## REQUEST FOR PROPOSALS

UK-2437-24 Softball Field Renovation ADDENDUM # 3 4/26/2024

## Written Questions and Answers

SITE LAYOUT AND DEVELOPMENT PLAN

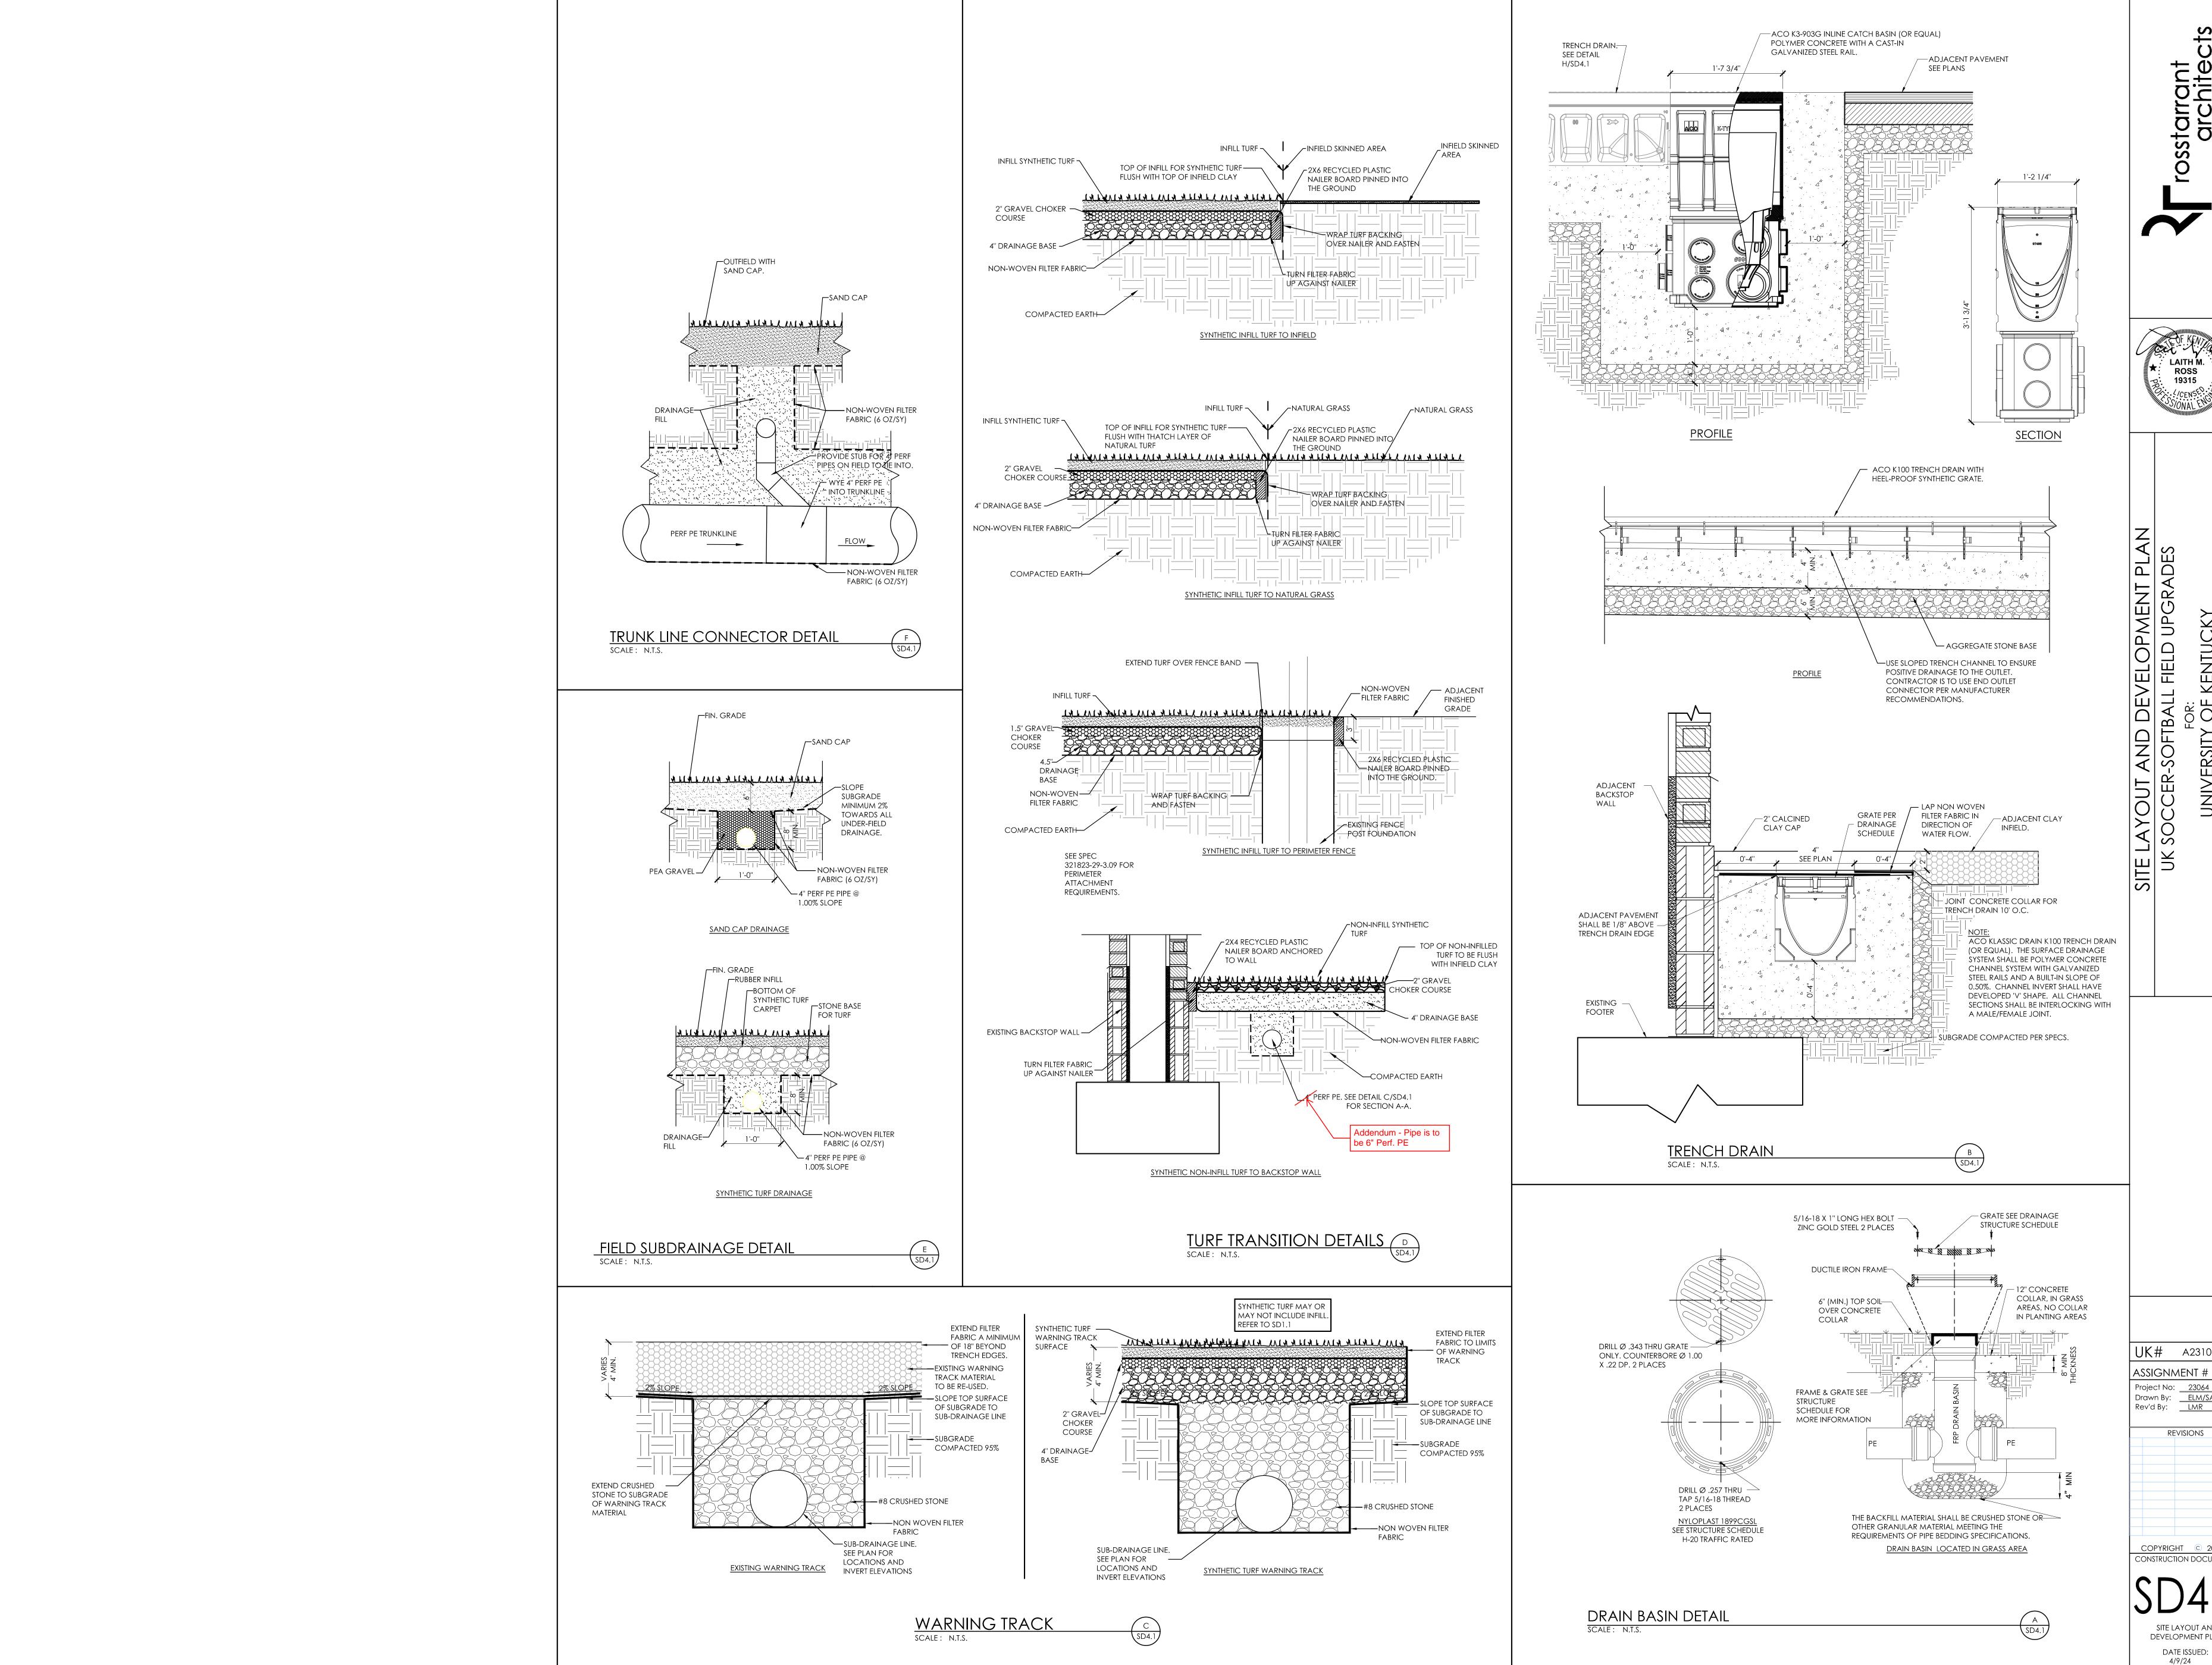
behind Homeplate/hip areas, can you please confirm the correct pipe size that is to be used for that?	
11	On plan sheet SD1.2 Site Layout and Development Plan – Alt #1, #2, & #3, Alternate 2C in center field indicates a transition is needed for warning track? Could you please confirm if there is a transition needed in that area?	The 2c tag located near DS-1 at the center field fence is an errant tag and should not be there. There is no synthetic transition at this location.
12	Will spoils need to be hauled off or can some be left on site/campus?	All spoils and debris are to be removed from the site by the successful awardee.

7	Is there clear access into the field on roads that can handle construction traffic wide enough the accommodate the trucks involved?	Yes
8	Noticed the plans put any utility work on the contractor. We will need a drawing and scope of the utilities involved to put a number in for this requirement.	Utility work to be done is irrigation as shown. Contractor is responsible for repair of any existing utilities damaged or impacted during the work.
9	There is clear language that the architect takes no responsibility of contamination on the site. Is there contamination on the site that this has to be factored in?	None is anticipated, but an environmental study has not been performed at the site.
10	For Alternate #3 - Detail D/SD4.1 shows a 4" Perf pipe being installed and plan sheet SD 2.1 shows a 6" perf pipe being installed	The pipe for Alt 3 along the dugouts and backstop wall is to be a 6" perf pipe.
